COLORADO
Division of Reclamation,
Mining and Safety
Department of Natural Resources

RE: Eagle-Gypsum Mine, File No. M-1984-041 , Technical Revision (TR-12) Adequacy Review #5

Bonding Spreadsheet

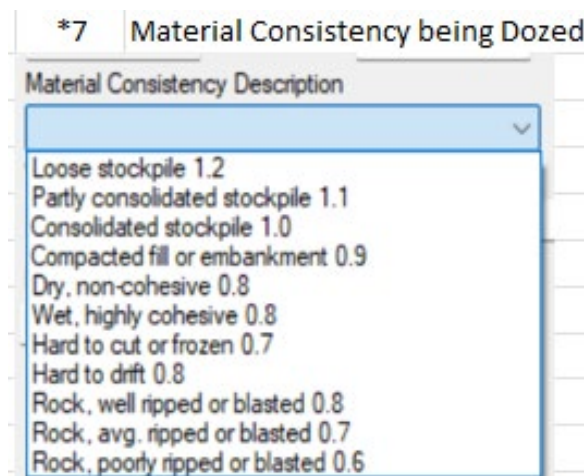
3. Incorrect correction factors were provided. Narrative descriptions do not match the factor utilized. See the pictures below.
